ITEM E3 - Grouse Creek Subdivision 2022 Addition

KPB File # 2022-022

Grouse Creek Subdivision 2022 Addition Preliminary Plat

STAFF REPORT

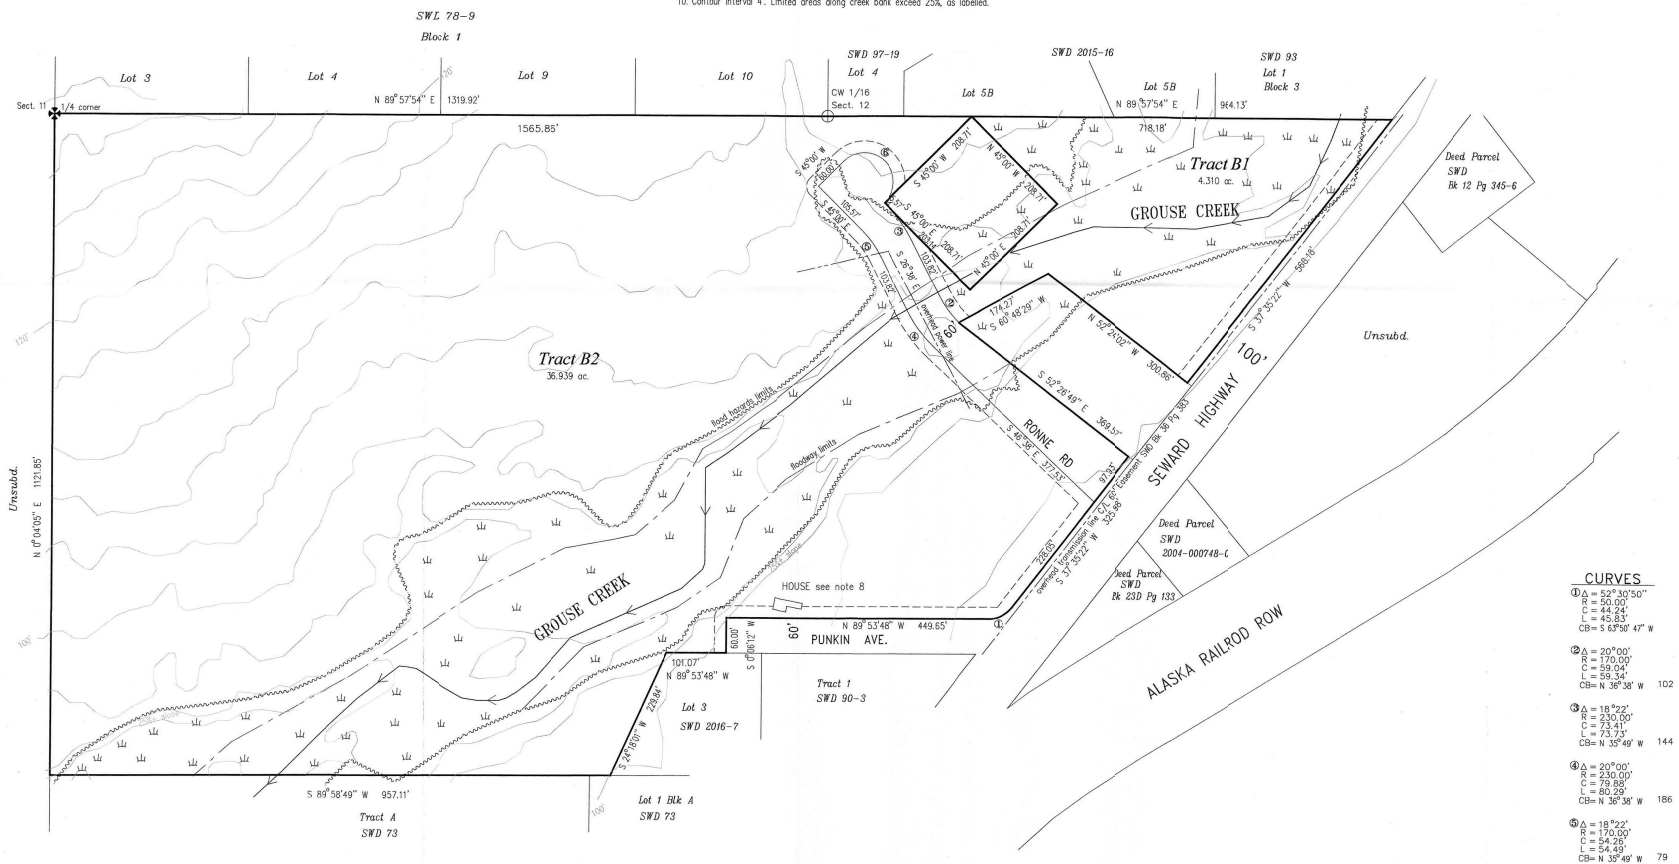
The plat, along with the parent plats, indicate a creek named Grouse Creek running through the subdivision. KPB GIS data indicates the name of the creek is Lost Creek. ***Staff recommends the surveyor verify the name of the subdivision for the final plat. The River Center may be assistance in verifying the name.***

The location of the creek will limit the ability for Tract B1 to use the new dedication for access and the creek runs through the narrow portion of the tract. Tract B2 is also divided by the creek but the northern portion will have access via the dedication. There appears to be an existing travelway that is used by multiple structures located thorough out the property and the Deed Parcel and Lot 1 from SW 88-11. The dedication appears to encompass the majority of that right of way. It does appear that the intersection with the Seward Highway may not be within the dedication. This should be verified. If a common or shared access through Tract B2 is to be used for the portion outside the new dedication ***staff recommends access or shared driveway easements be recorded by separate document and noted on the plat.***

Site Investigation: The proposed subdivision has slopes throughout with areas with slopes greater than 25 percent labeled. **Staff recommends the toe and/or top of any steep bluffs be depicted and labeled on the final plat if not in conflict with other required information.**

Plat notes are present on the plat. Flood Hazard and Floodway notices are present as notes 5 and 6. Per the comment received by the Seward Bear Creek Flood Service Area, **staff recommends adding to the flood hazard notice or adding an additional note, "Portions of the parcel are also designated as Seward Mapped Flood Data Area as included in the Flood Risk Assessment and Hydrologic and Hydraulic Report."**

Utility Easements Grouse Creek Subdivision 2016 Addition, Plat SW 2016-7, granted 15 foot utility easements along the right of ways of Punkin Avenue and the Seward Highway. **Staff recommends plat note 1 be revised to remove the portion “extending to 20’ within 5’ of side lot lines.”**

An additional easement was granted by document for existing lines. Per the attachment recorded with the easement, this easement runs through portions of Tract B2 to the Deed lot. The plat is depicting some overhead lines within the proposed dedication and within portions of Tract B2. **Staff recommends the depiction of the easement as granted be shown on the plat with a reference to the recording document or provide a plat note.**

The building setback is depicted but requires a label.

- Staff recommendation:** *Update the description to "N1/2 SW ¼". Verify the owner's address as KPB Assessing has a Primrose Road address listed.*
- C. The location, width, and name of existing or platted streets and public ways, railroad rights-of-way, and other important features such as section lines or political subdivisions or municipal corporation boundaries abutting the subdivision;
Staff recommendation: *Provide a width label for the Alaska Railroad ROW.*

- D. A vicinity map, drawn to scale showing location of proposed subdivision, north arrow if different from plat orientation, township and range, section lines, roads, political boundaries, and prominent natural and manmade features, such as shorelines or streams;
Staff recommendation: *Remove any overstrikes of labels. Provide a label for the Chugach National Forest.*

- Lot "5B" to the north, needs corrected to "5A".
- A label is needed for Lot 1 of SW 88-11.
- A label is needed for the Deed Parcel located in the middle of this subdivision.

- Correct "then" to "the" within the first line of plat note 6.
- Correct the spelling of "Reservation" within plat note 9.
- Provide the plat notes as required and noted within the staff report.
